**Proposed Amendment to the Drawings:**

**Remarks**

FIG. 3

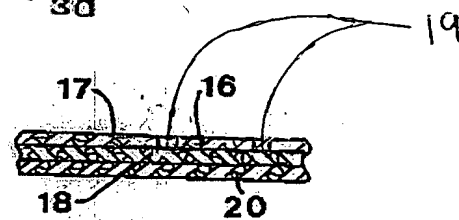
The attached annotated sheet (illustrating Figs. 1A, 1B, 2 and 3) includes a proposed change to FIG. 3. In FIG. 3, reference numeral 19 and holes in the upper layer 16 have been added.

A proposal to amend FIG. 3 is submitted herewith, which illustrates holes in the upper layer 16 and further provides a reference numeral 19 and a lead line for the reference numeral 19 that points to the holes, as described in the paragraph starting on page 10, line 28. In addition, the specification has been amended to include references to numeral 19 in the paragraph starting at page 10, line 28.
